Gachsaran Polymer Industries Company HDPE Plant		
	LCP and Junction Box Layout, Arrangement and Wiring Drawing for Refrigerator Package		 
PO No.: GPIC-PT-MA-PO-000-3029	Document Number: VD-GPIC-MA-3029-3029-0046	Rev. 00	Page 1 of 14

LCP and Junction Box Layout, Arrangement and Wiring Drawing for Refrigerator Package

JB-UEV-652

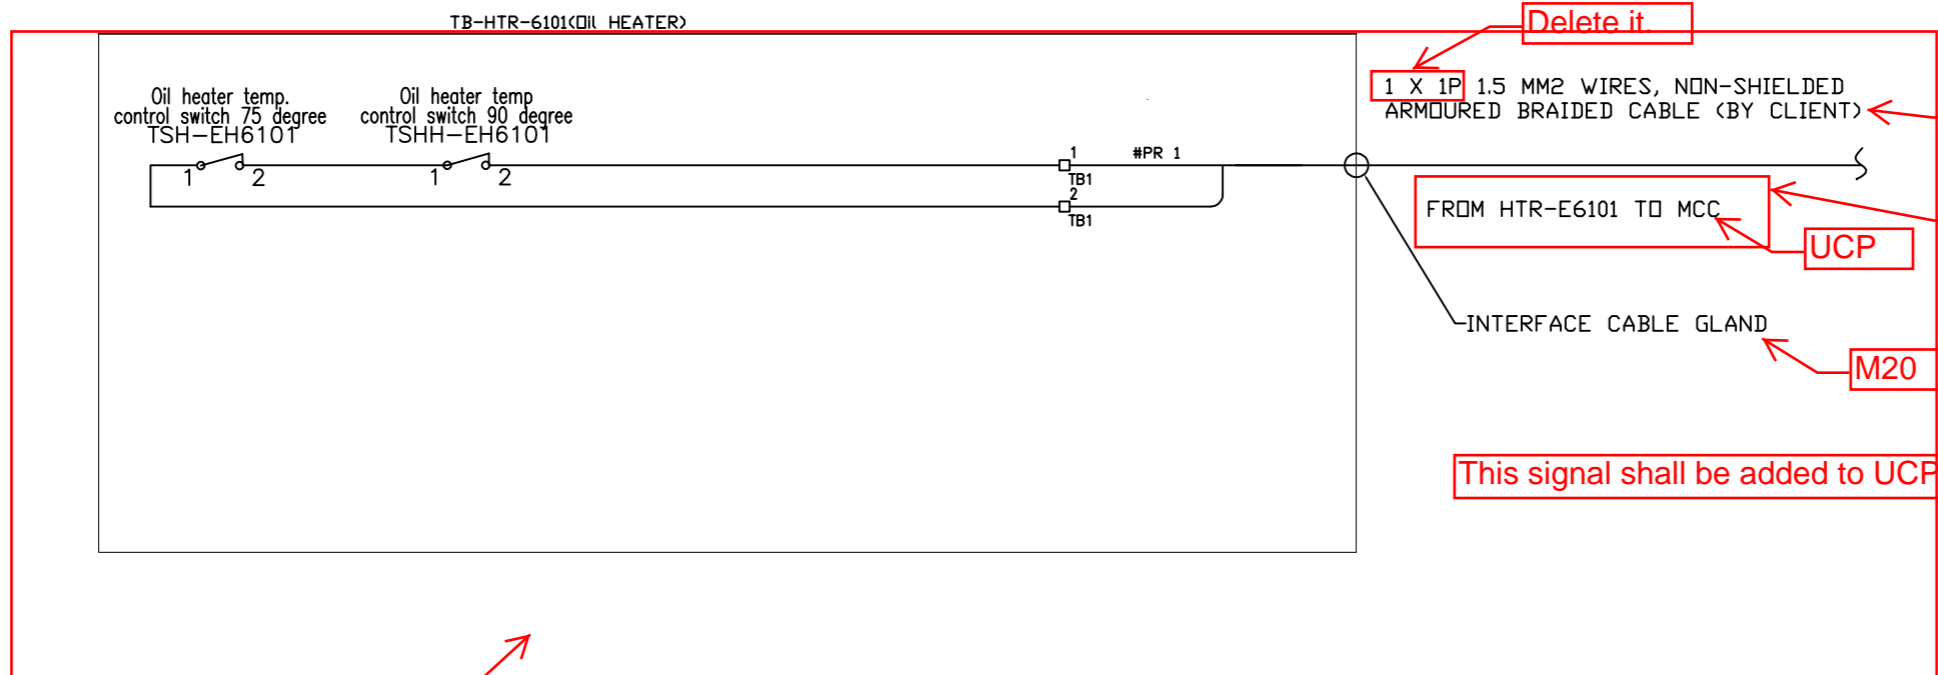
"FRT-01Px2.5mm² SWA/NIS/GRAY (300/500)"
for all single pair cables.

Delete it.

Add cable tag: IC-UEV-652

FRT-04Px2.5mm² SWA/NIS/GRAY (300/500)
